## LOEHMANN'S PLAZA

### SKETCH PLAN NO. 320230050

No. 320230050

Completed: 10-30-2023

Figure 4: Proposed Sketch Plan – Interim Buildout with Phases I & II

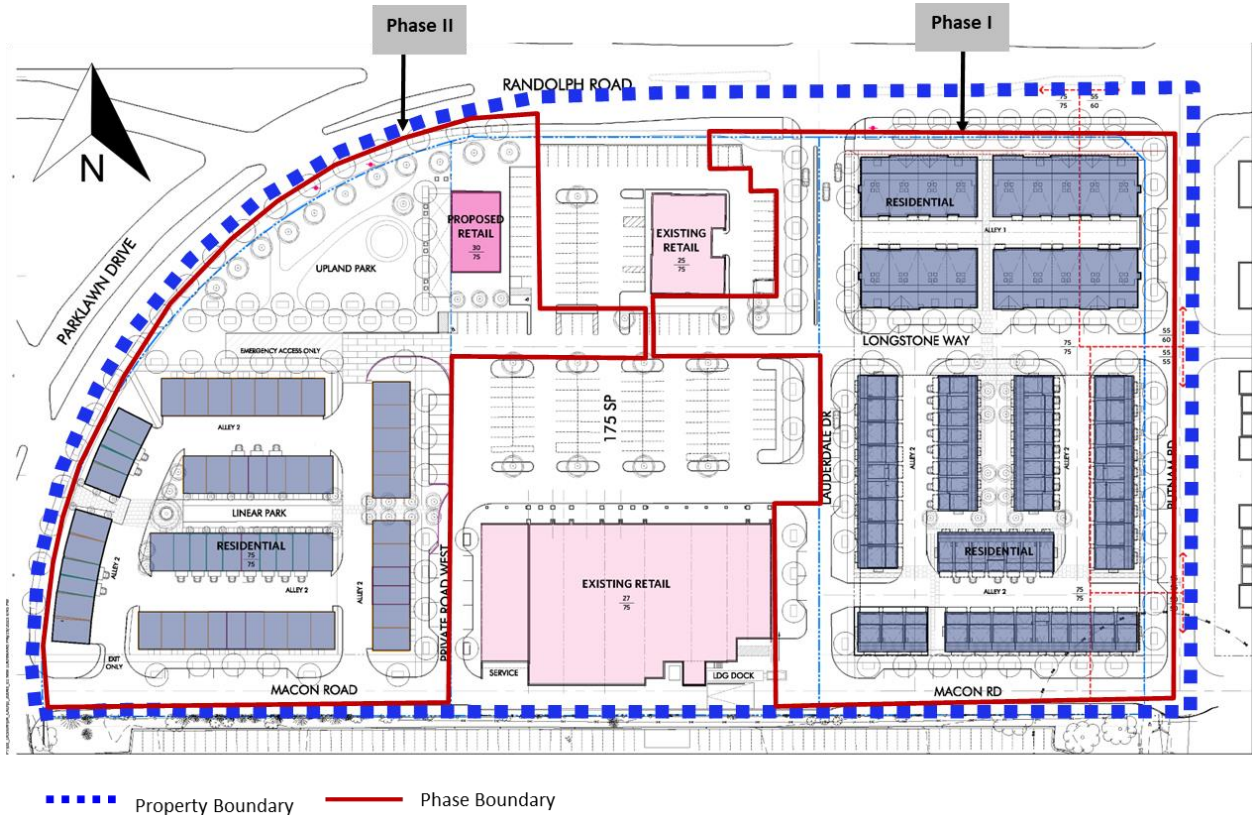
Based on the proposed phasing plan (Figure 4), some of the common open space required for the townhouses to the east of Lauderdale Drive (Phase I) is anticipated to be implemented with the townhouses to the west of Private Road West (Phase II). The Applicant also provided an Open Space Phasing Plan that shows the neighborhood green urban park in Phase III associated with the multifamily building. Considering that the Applicant's phases could occur in any order, there is a possibility that the creation of the remainder of this common open space could be implemented too late in the redevelopment or never come to fruition at all. As conditioned, each future Site Plan must provide the minimum required open space.

- h) Each future Site Plan must provide the minimum required open space.
- i) Based on the differences between the Overall Phasing Plan and the Open Space Phasing Plan, provide clarification on when the 0.75-acre neighborhood green urban park will be constructed.

Figure 10: Concept for the Reconfiguration of the Randolph Road and Parklawn Drive Intersection with Annotations

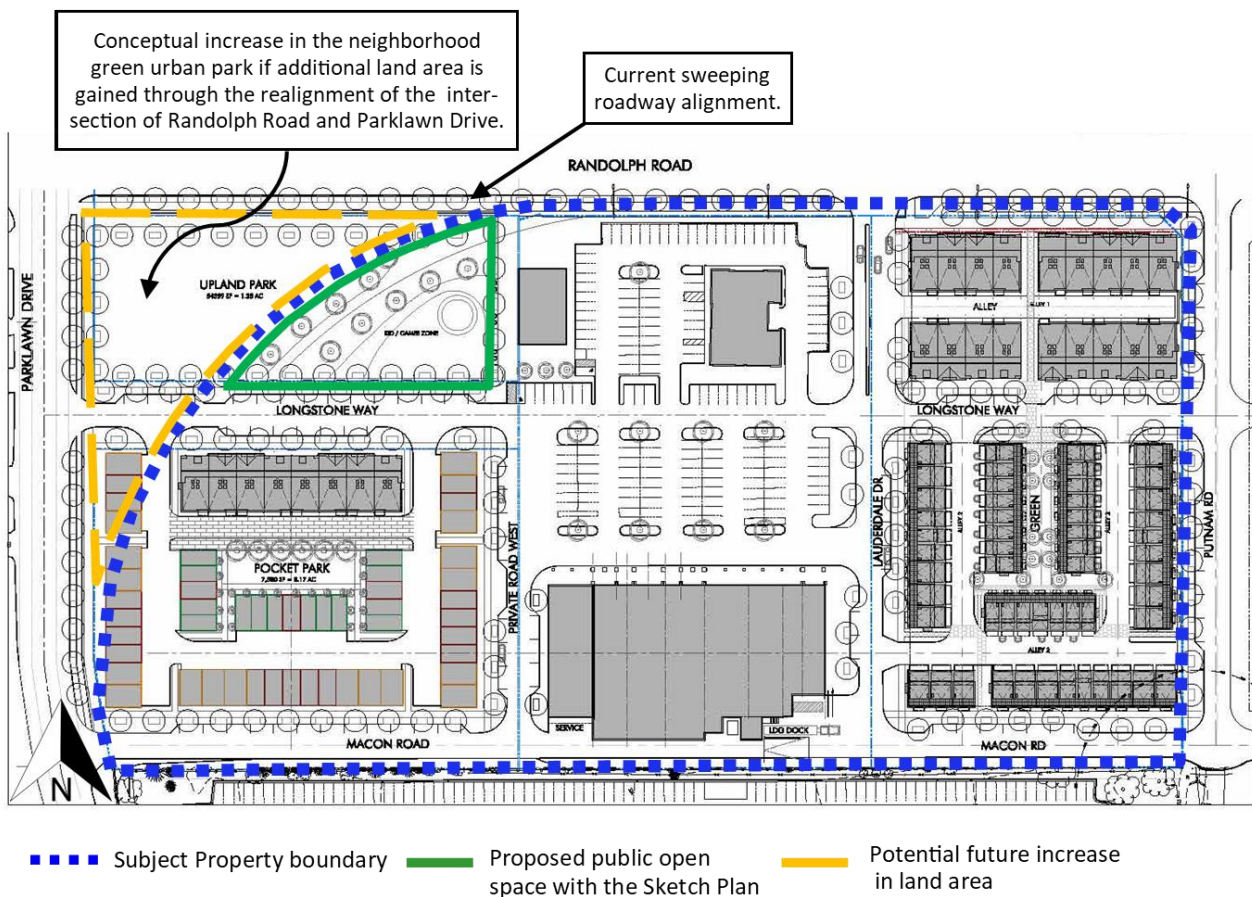
The 2018 *White Flint 2 Sector Plan* recommends the realignment of the curved Parklawn Drive section of the intersection with Randolph Road to form a traditional four-way intersection. While there is currently no design or funding via the Capital Improvement Program (CIP) to complete this realignment, the potential realignment concept was considered in the submitted application of this Project. As conditioned, at the time of the Preliminary Plan an easement for future dedication must be provided to allow the extension of Longstone Way to the west to allow for a future connection with Parklawn Drive. Similarly, an easement for future dedication must be provided to allow the extension of Private Road West to connect with Randolph Road to the north. Future applications will also need to address all applicable design guidelines for the Project's roadway improvements.

- z) Address the requirements of the MCDOT letter dated October 6, 2023.
- aa) The future Preliminary and Site Plan(s) need to reflect the Capital Improvement Program (CIP) status of the realignment of the Randolph Road and Parklawn Drive intersection, at the time of the Applicant's submittal. Any potential recapture of land associated with the

Figure 11: Randolph Road Proposed Cross-Section

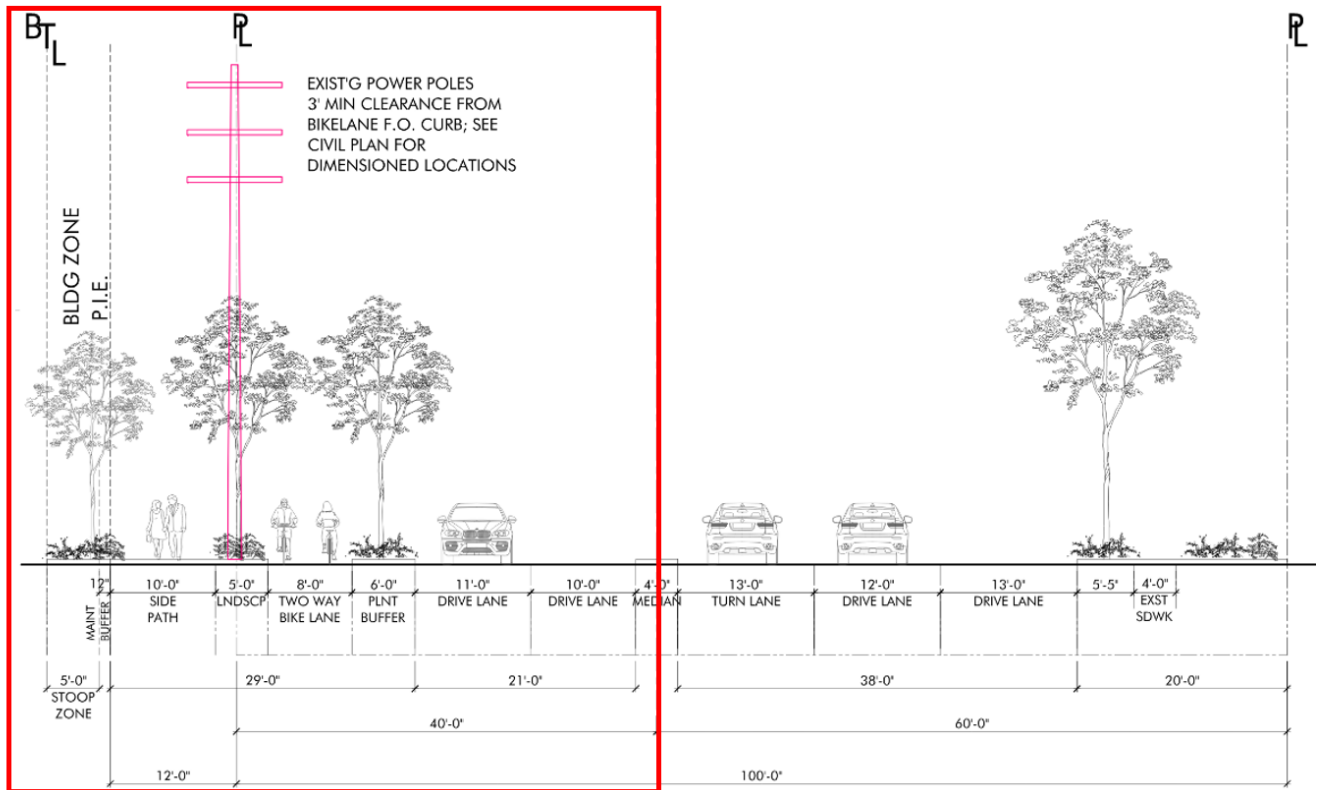
Further, the Urban Design Guidelines for Rock Spring and White Flint 2 Sector Plans identify cross-sections for Randolph Road and Parklawn Drive along the Subject Property frontage. Randolph Road has a six-foot-wide street buffer, eight-foot-wide separated bike lane, 5-foot-wide pedestrian/bike buffer, and a six-foot-wide sidewalk. Parklawn Drive has a seven-foot-wide street buffer and a ten-foot-wide sidepath. Both streets are under consideration for Bus Rapid Transit (BRT), but buses are expected to operate in mixed traffic. Therefore, as conditioned, future applications will need to modify the proposed road cross-sections to comply with the guidelines.

- o) Modify the proposed road cross-sections to comply with the minimum widths stated on the Urban Design Guidelines for Rock Spring and White Flint 2 Sector Plans, where applicable.
